April 26, 1990

RE: Comments to Wallace Roberts & Todd General Plan Amendment
Dated March 19, 1990

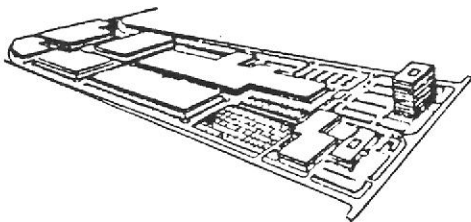
II-2 Last paragraph should be modified to allow development of areas of the site that have not been identified to be subject to health and safety. The site is presently in use as a retail site and has proved to be adaptable for human use and safety.
